## **Ontario Energy Board**

**AND IN THE MATTER OF** the Application by Alectra  
Utilities for 2020 Electricity Distribution Rates.

**Interrogatories to Alectra Utilities**

**July 29, 2019**

Figure 1: 2017 SAIFI (excluding MEDs and LoS)

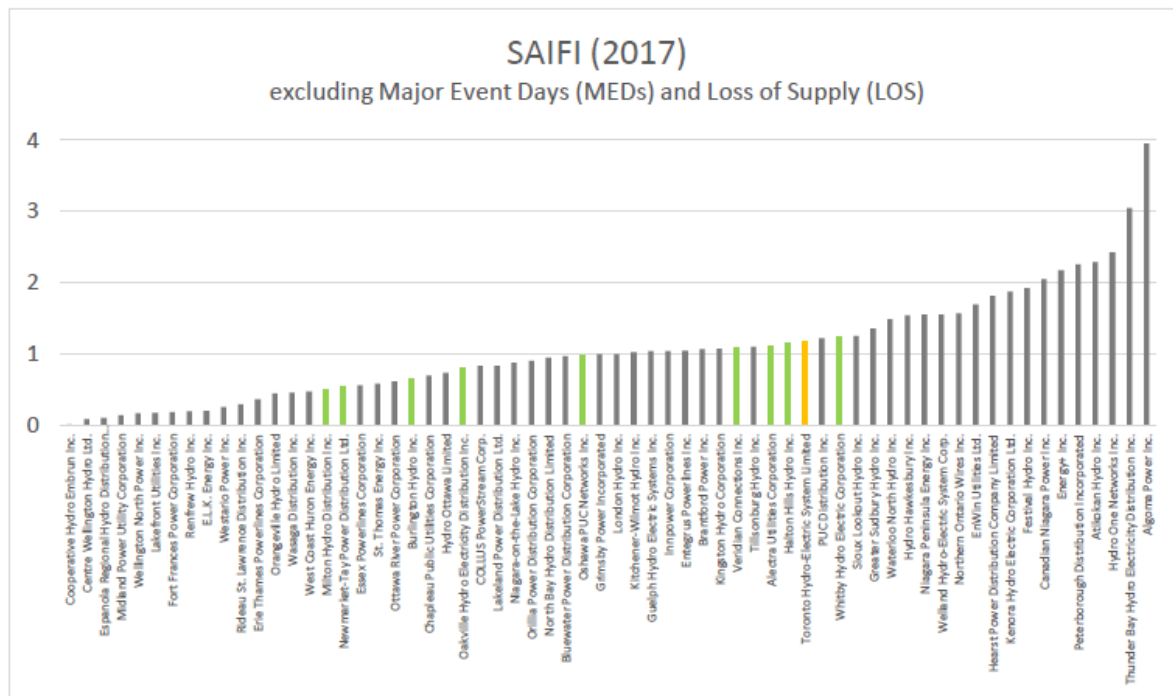
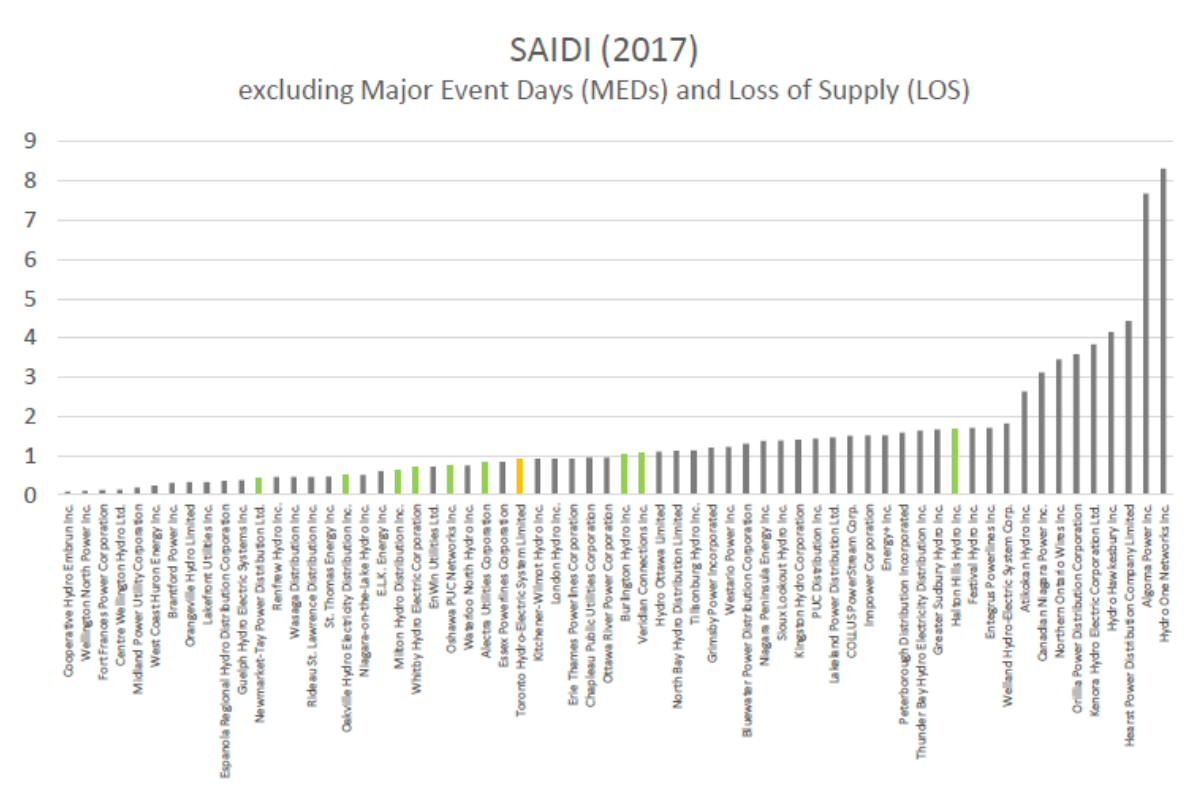
- c) Please position both the former utilities/RZs and Alectra in the Ontario SAIDI and SAIFI cohorts indicating positioning by quartile for each. Attached are Charts with 2017 data from EB-2018-0165 Toronto Hydro evidence, to assist with the response.
